**OFFICE OF NUCLEAR MATERIAL SAFETY  
AND SAFEGUARDS  
SAFETY EVALUATION REPORT  
REVIEW OF FINAL STATUS SURVEY REPORT  
FOR THE MALLINCKRODT SITE IN ST. LOUIS, MISSOURI  
LICENSE NO. STB-401      DOCKET NO. 40-6563  
MALLINCKRODT, LLC.  
ST. LOUIS, MISSOURI**

**Figure 2-1 Sewer lines (from C-T Phase II DP Figure 4-1 and FSSR Figure 4-4)**

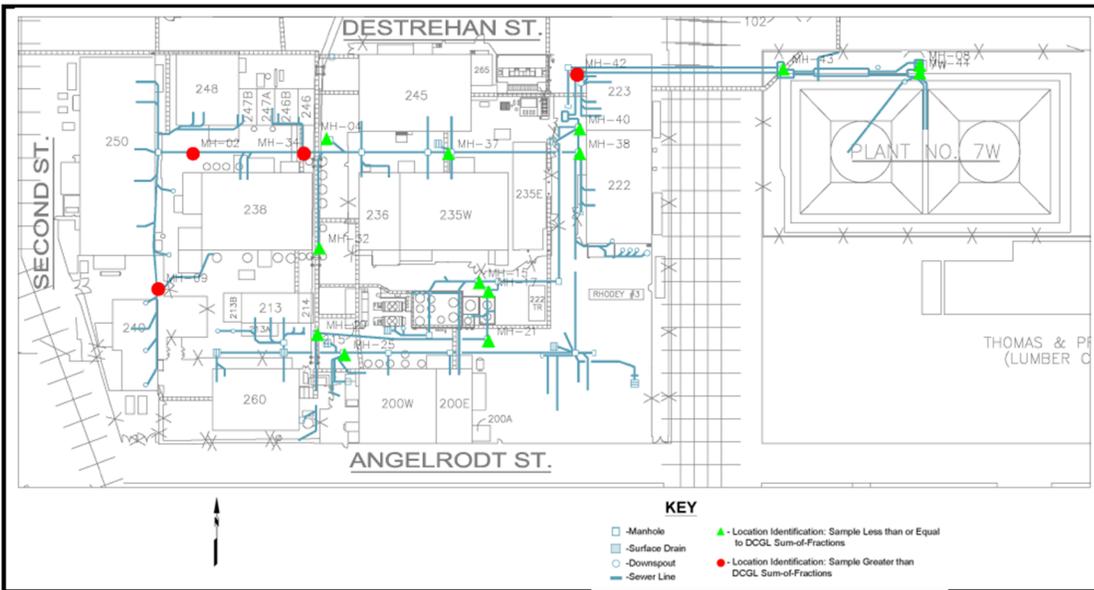
The NRC staff finds that the survey unit classifications are consistent with guidance in MARSSIM, with the exception that the sewer survey unit should have been a higher class than Class 3 because it had concentrations above the DCGL<sub>w</sub> in one manhole, MH42, which is discussed in detail below. The characterization of the sewers is discussed in more detail in Section 3. Additionally, the NRC staff finds that the data analysis approach that Mallinckrodt used for the systematic samples is consistent with guidance in MARSSIM. The NRC staff concluded that the use of the dose assessment approach to evaluate elevated areas is acceptable in its approval of license amendment 7.

Figure 2-2 Plant 5 Pavement Survey Units (from FSSR Figure 6-1)

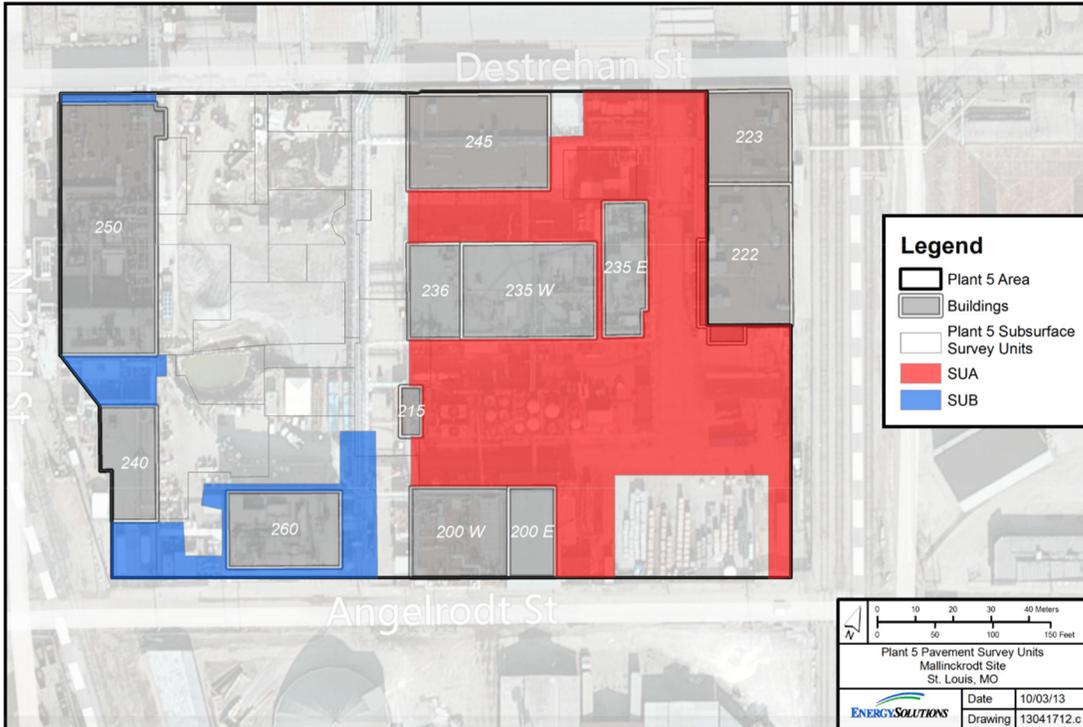
For the Class 3 pavement SUA and SUB, 10 percent beta surface scan coverage was planned. Chapter 6 referred the reader to chapter Figures 6-2 and 6-3 for the surface scan data. The surface scan results, based on the z-scores of the count rates, were plotted on an overlay map for SUA (Figure 6-2 in FSSR). The illustrated scanning coverage showed that the 10 percent scanning density coverage was met or exceeded. The z-scores were not plotted for SUB, but the text indicates that the scanning coverage of SUB was approximately 100 percent and the maximum beta reading recorded was 9,210 dpm/100 cm<sup>2</sup> (ML15334A417).

The NRC staff review concluded that Mallinckrodt surveyed the Plant 5 pavement in accordance with their DP. The NRC staff finds that the method that Mallinckrodt used verify that the use of large area detector was not missing elevated areas (i.e., calculating the maximum possible hot spot activity levels by assuming all activity measured by the detector was present within a 100 cm<sup>2</sup> area) is acceptable because this approach is conservative. Since all direct systematic and biased surface measurements in SUA and SUB were well below the DCGL<sub>w</sub> value approved in the Phase II C-T DP, the NRC staff concludes that Mallinckrodt demonstrated that the Plant 5 Pavement meets the DCGL<sub>w</sub> value.

**Figure 2-3 Plant 7 Pavement Survey Units (from FSSR Figure 30-1)**

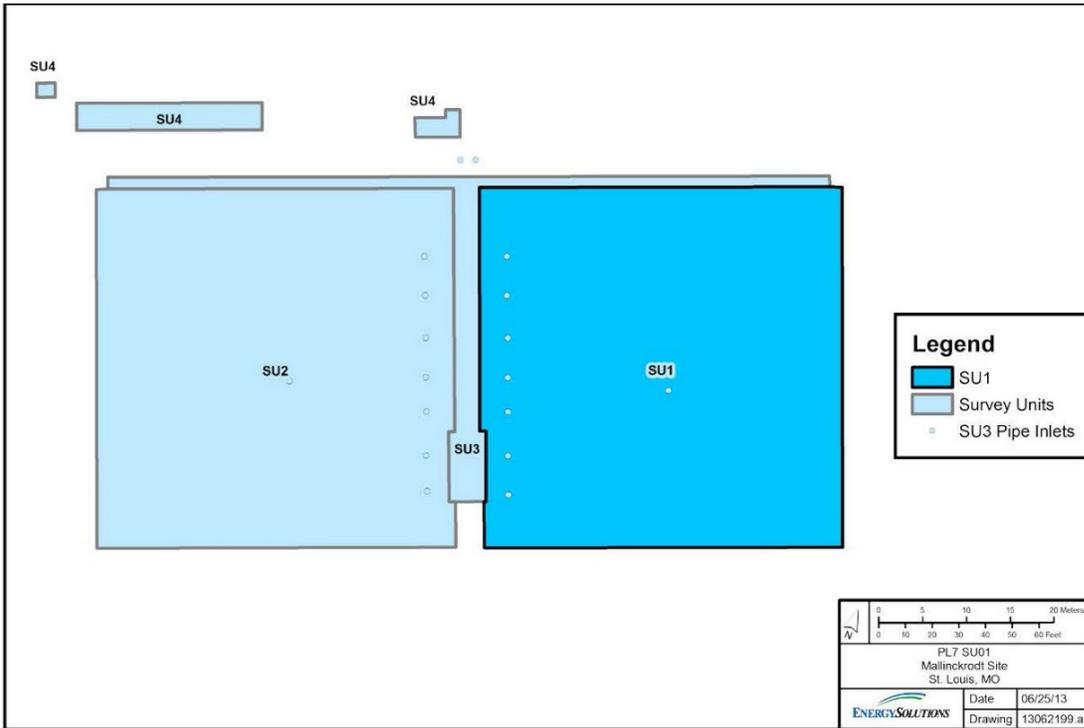
The NRC staff reviewed the Plant 7 results. The NRC review confirmed that the surface scan results, based on the z-scores of the count rates, were plotted on an overlay map for each survey unit, and the illustrated scanning coverage appeared to represent that greater than 10 percent scanning density coverage was met, and the data plots were indicative of medium to high density scan coverage. Neither the figures nor the narrative text provided specific scan range summaries. There were numerous apparent locations of elevated beta radiation, the  $> +3$  z-scores represented in red on the maps. As noted for Plant 5 subsurface gamma walkover survey data presentation, the z-score method for presenting scan data did not make it possible for the NRC review to evaluate the relative count rate magnitude of the various anomalies. As all anomalies were not subjected to individual biased measurements, the NRC's review cannot confirm that biased measurements were collected from locations with the maximum observed count rates. However, Figures 30-4, 31-4, 32-12, and 33-14 in the FSSR, indicate that biased

samples were taken from all significant anomalies. For this reason, the NRC staff concludes that Plant 7 was surveyed appropriately. The measured results in Plant 7 were all less than the DCGL<sub>W</sub> value for pavement. As was discussed in Section 5.5.1, the NRC staff finds that the method that Mallinckrodt used to verify that the use of large area detector was not missing elevated areas is acceptable. The NRC staff therefore concludes that Mallinckrodt demonstrated that Plant 7 meets the DCGL<sub>W</sub> value.

**Figure 2-4 Subsurface Survey Units (based on Figure 4-6 in Mallinckrodt’s FSSR)**

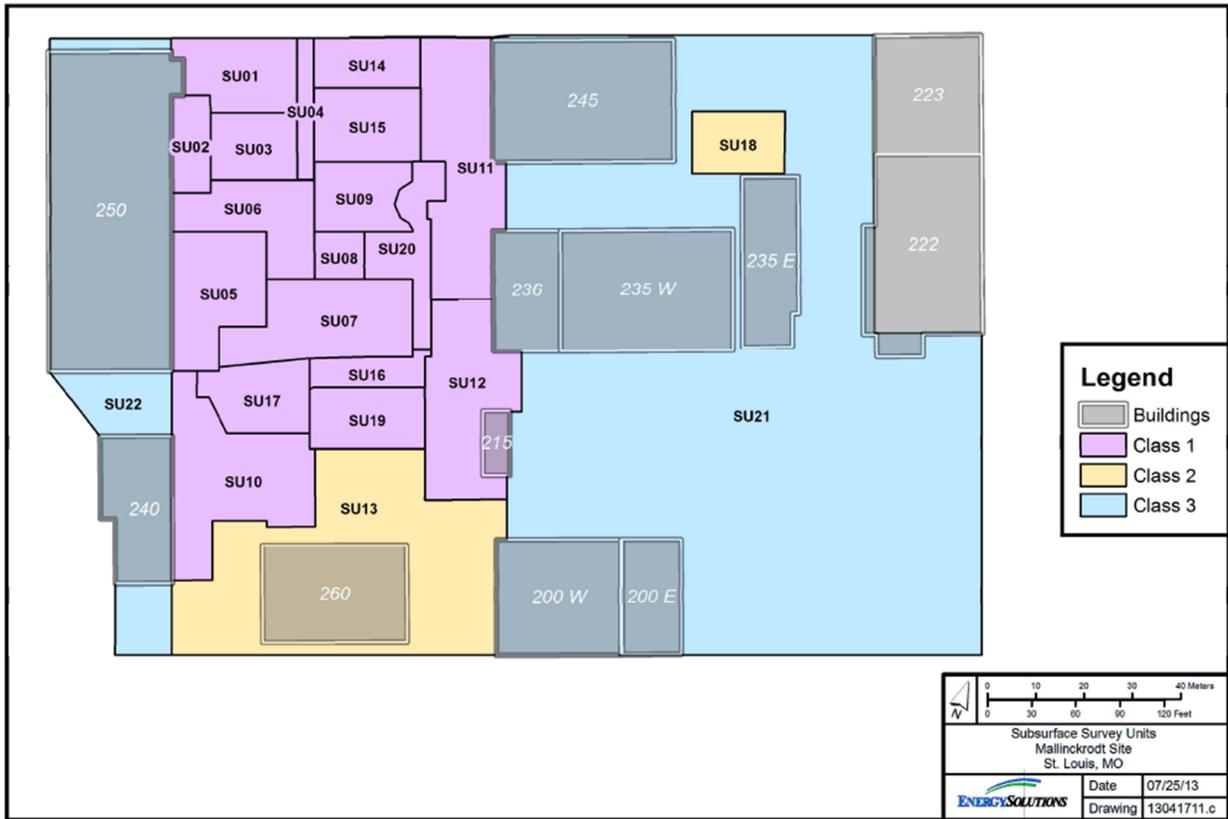
Finally, a GWS was not performed inside Buildings 240 and 250 even though they are in a Class 1 survey unit (SU22). The NRC requested that the licensee either perform a 100 percent GWS of SU22 or provide justification for how the FSS is sufficient without the GWS inside these buildings. The licensee's response to this RAI indicated that in lieu of scans, 15 systematic borehole samples were collected throughout the buildings and the sample results did not identify contamination of concern beneath the buildings. The licensee's response also indicated

that the results for the additional biased samples collected throughout SU22, where residual contamination or elevated radiation levels were identified, provide further information to support the assumption that contamination that was identified was due to the sewer lines that ran along the two buildings and that contamination did not extend laterally beneath the buildings.
